# RWR Pilot Training

## Alternate Air Door Issues

# SERVICE No. 961 BULLETIN

Alternate Air Door Replacement  
 and Control Linkage Inspection

SKETCH A

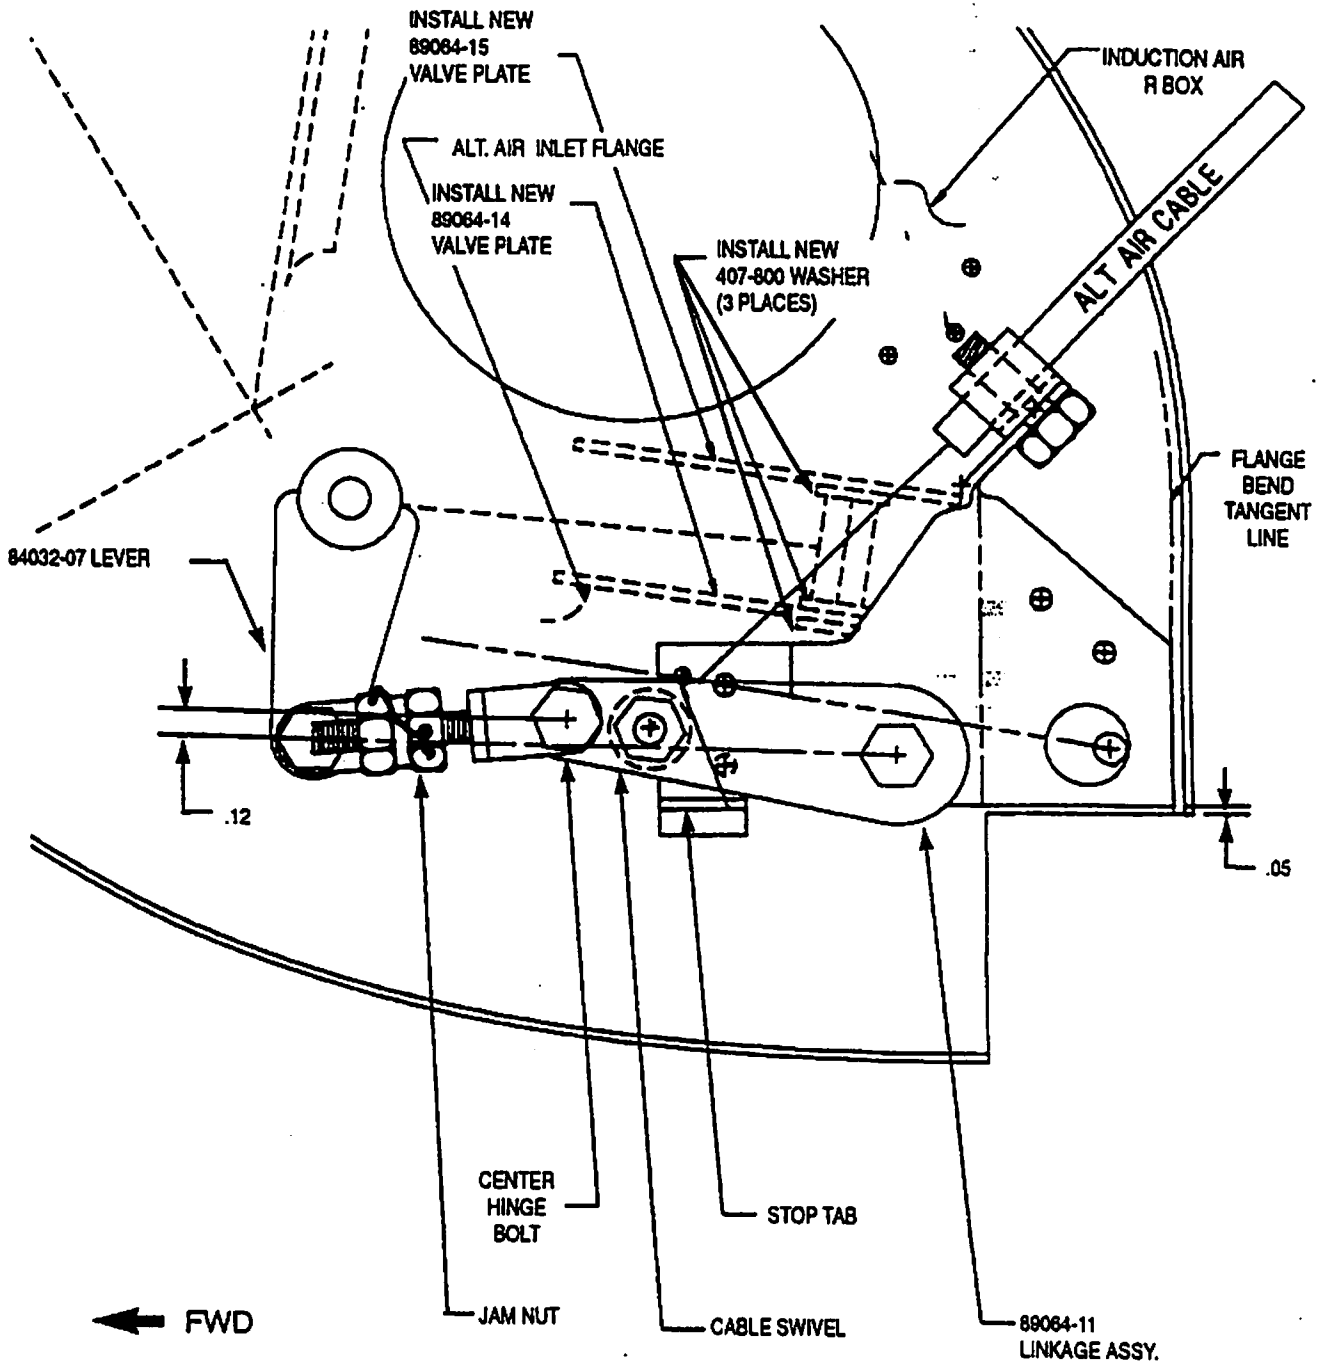
3. Refer to Sketch A. Remove existing cable clamps and hardware. Remove existing swivel and retain hardware for re-use except discard cotter pin.
4. Remove existing alternate air valve plates and six (6) each P/N 404-564 washers. Retain only the bolts for re-use.

5. Install the new P/N 89064-14 valve plate (lower) and new P/N 89064-15 valve plate (upper). Use bolts removed per instruction 4 and six (6) new P/N 407-800 washers. Torque the bolts to 33 inch lbs.  
NOTE: aircraft serial numbers 4622117 through 4622127 may have the new P/N 407-800 washers already installed.

6. Inspect alternate air door linkage and hardware thoroughly and replace parts as necessary (P/N 89064-11 linkage and P/N 89064-07 crank). There should be no appreciable "slop" evident before making the rigging adjustments.

7. Make rigging adjustment as necessary. Assure lever meets stop tab when lever is  $.12 + .06/-0$  inch before center. This may be accomplished by making a measurement between the center of the P/N 89064-07 crank bolt and the bolt at the opposite end of the linkage and measuring up  $.12$ " to the center of the center hinge bolt. Make adjustments to jam nuts as required to seal the P/N 89064-14 valve plate. Localized gaps between valve and alternate air inlet flange are not to exceed  $.015$ ". When making this adjustment the linkage should rest on the stop with no pressure on the lower valve plate. In order to assure that no distortion is present, it will be necessary to remove the two induction air hoses located on either side of the air box. With a strong light observe the plate with the alternate air selected and deselected. There should not be any distortion in the plate when engaging the door. Tighten jam nuts and safety wire together. Use  $.032$  stainless steel wire.

FIGURE 1

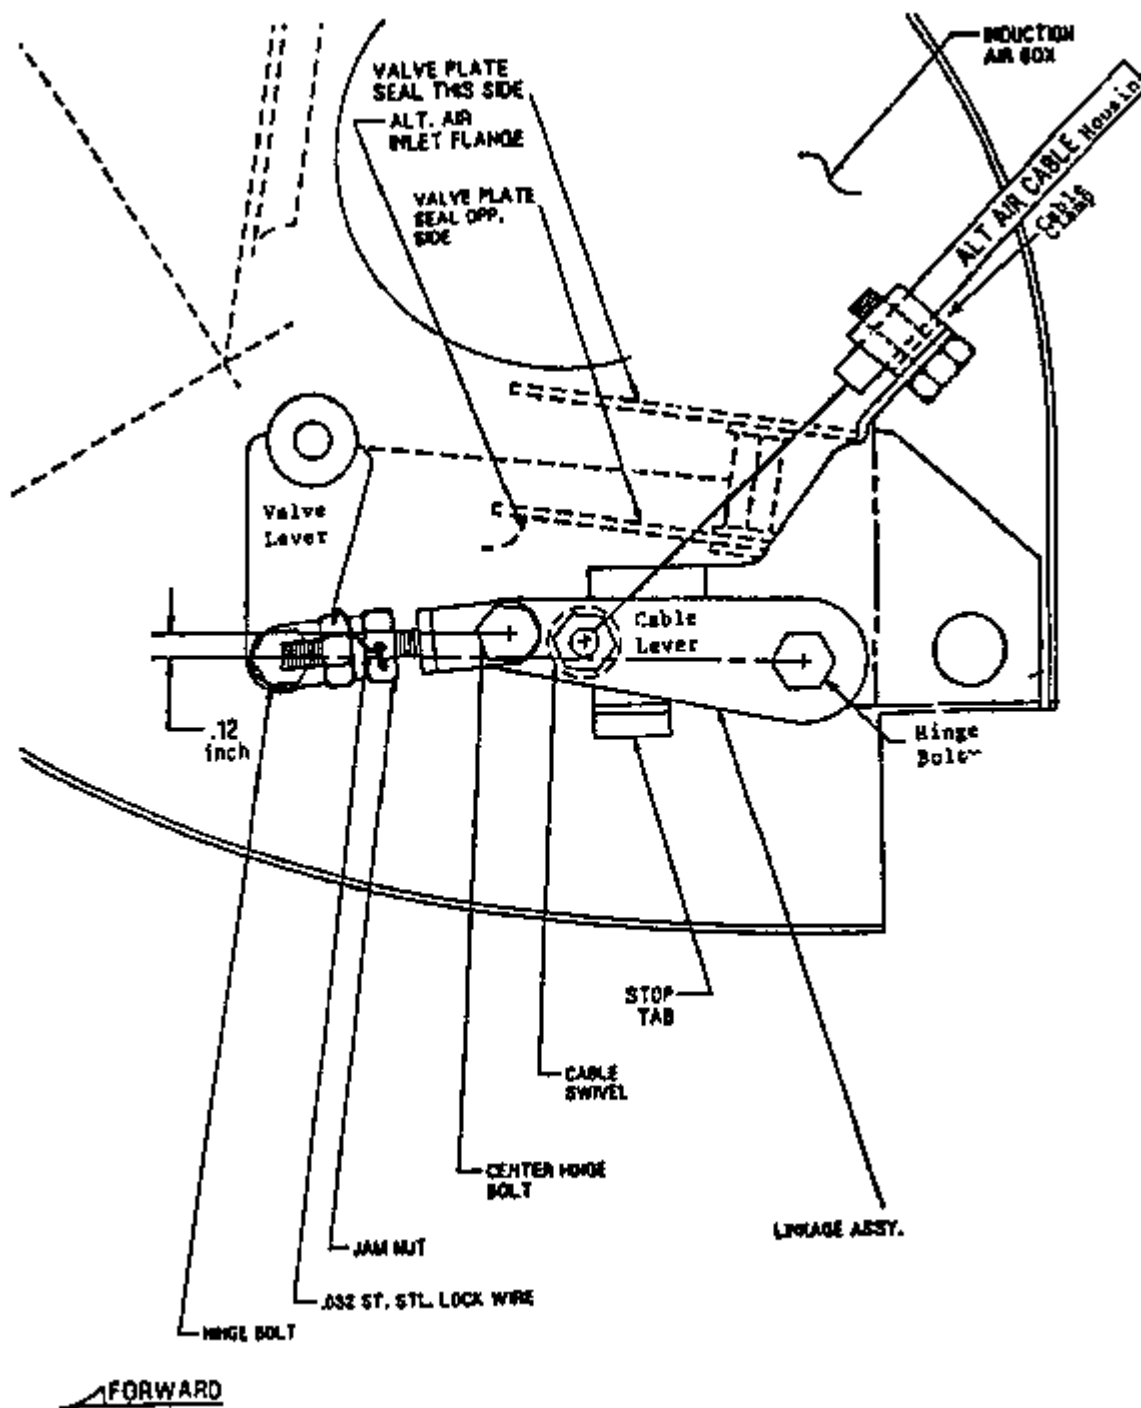
- (a) Remove the top and the lower left-hand engine cowl.
- (b) Determine whether or not the alternate air valve linkage shown in Figure 1. has been installed on the left side of the engine air box.

- (2) If the alternate air valve linkage shown in Figure 1. is installed, accomplish the following unless already accomplished in accordance with Piper Service Bulletin 852 dated November 14, 1986:

- (i) Position the alternate air control (located inside the cockpit) approximately mid-way between the primary and the alternate position.
    - (ii) Refer to Figure 1. and bend the stop tab so that the linkage is stopped 0.12 inch plus 0.060 minus 0.000 inch before center. This dimension is determined by measuring the perpendicular distance between a line through the centers of the cable lever and the valve lever hinge bolts and the center point of the center hinge bolt.

SKETCH "A"

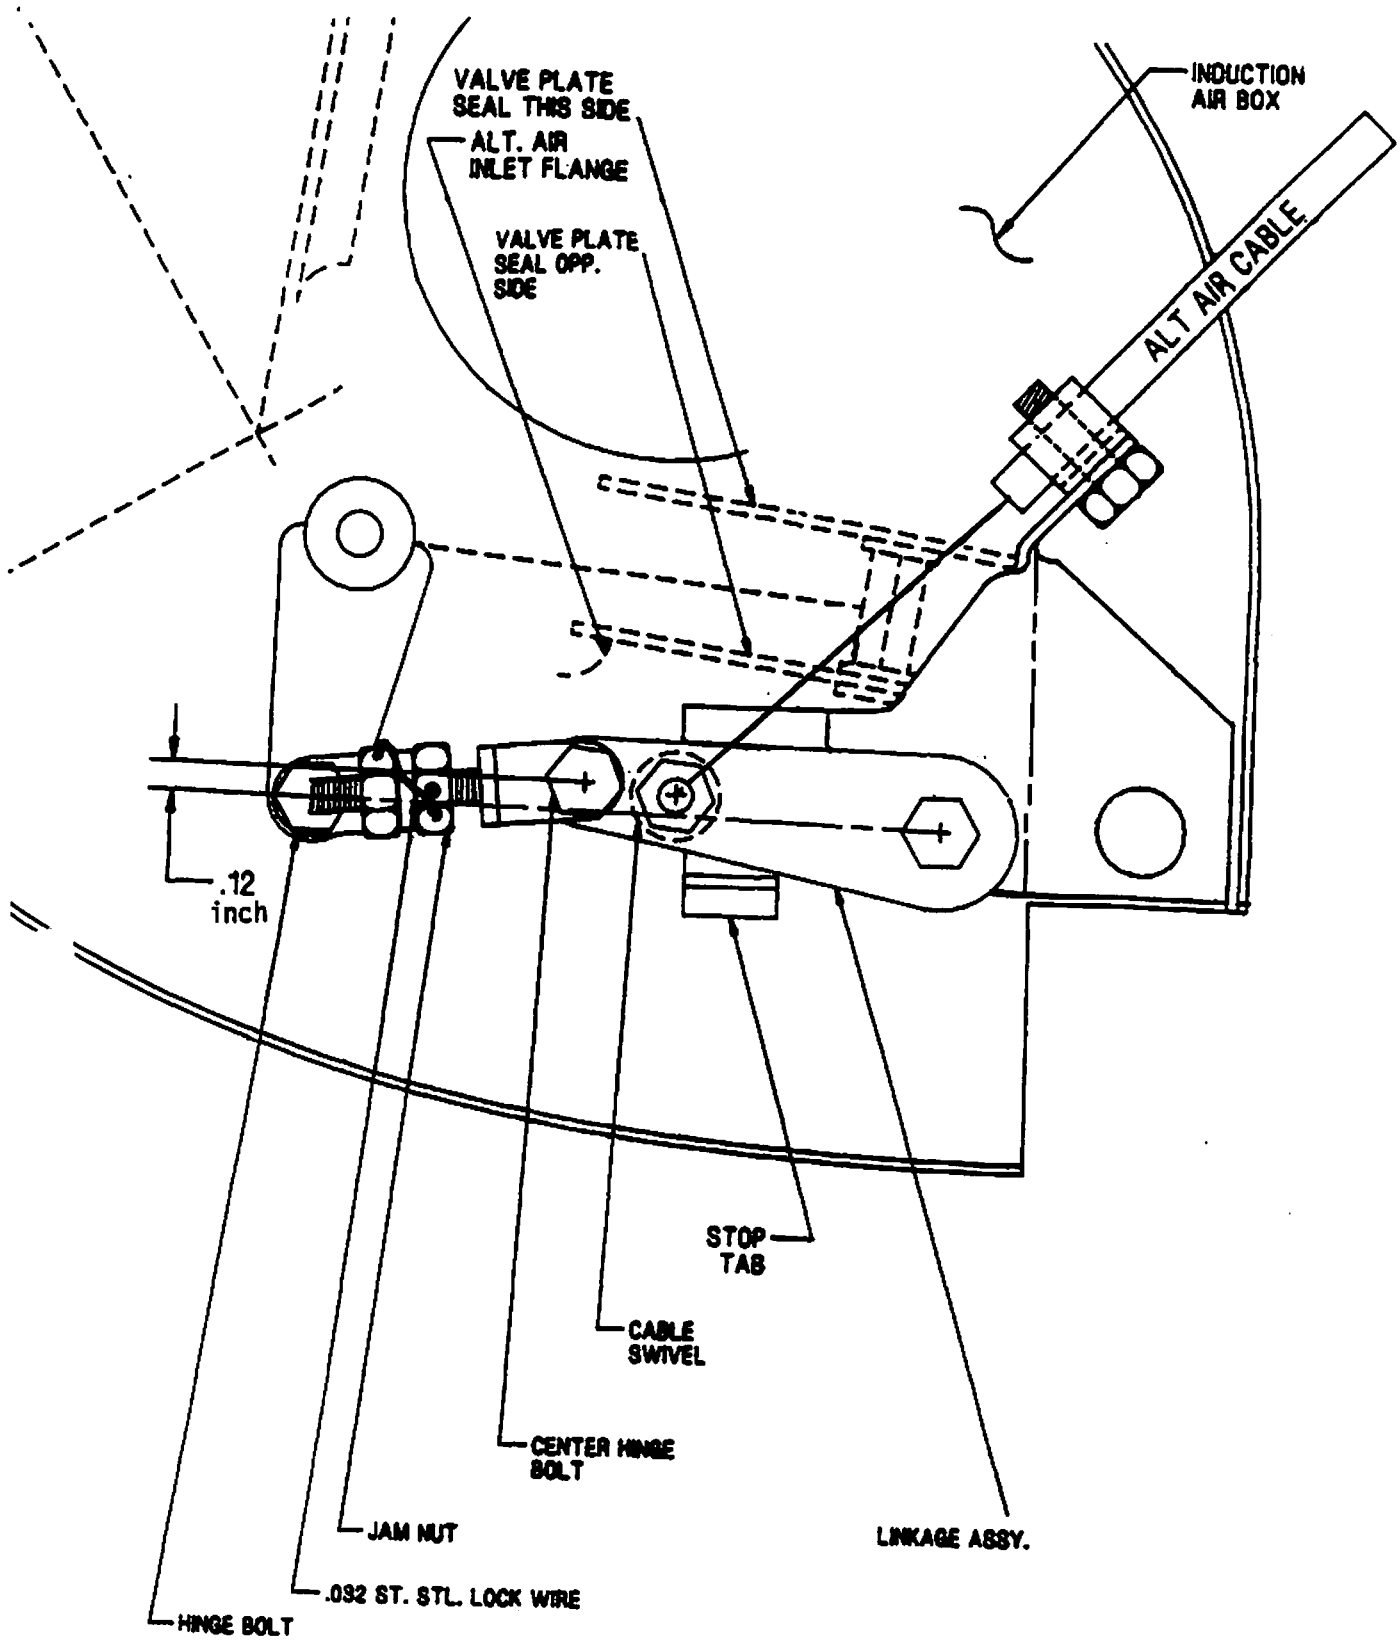
1. Remove top and lower left hand engine cowl.
2. Locate alternate air valve linkage on left side of engine air box. See Sketch "A" attached.
3. Position the alternate air control (inside the cockpit) approximately mid-way between primary and alternate position.
4. Bend stop tab so that linkage is stopped 0.12 inch + 0.060/- 0.0 inch before center. Take measurement from line between the center of the bolt that is the hinge point for the cable lever and the center of the bolt that is the hinge point for the valve lever.

5. Position the alternate air control (inside cockpit) in the primary (up position). Insure that the control is in the gate that prevents it from springing downward.
6. Adjust cable housing in cable clamp so that cable pushes linkage against the stop. Tighten cable clamp.
7. Operate alternate air control (inside cockpit) between primary and alternate air position. Verify that operation is normal and that the linkage does not go over center when control is in the "primary position".
8. Reinstall lower left hand and top engine cowl.
9. Make a logbook entry of compliance with this Service Bulletin.
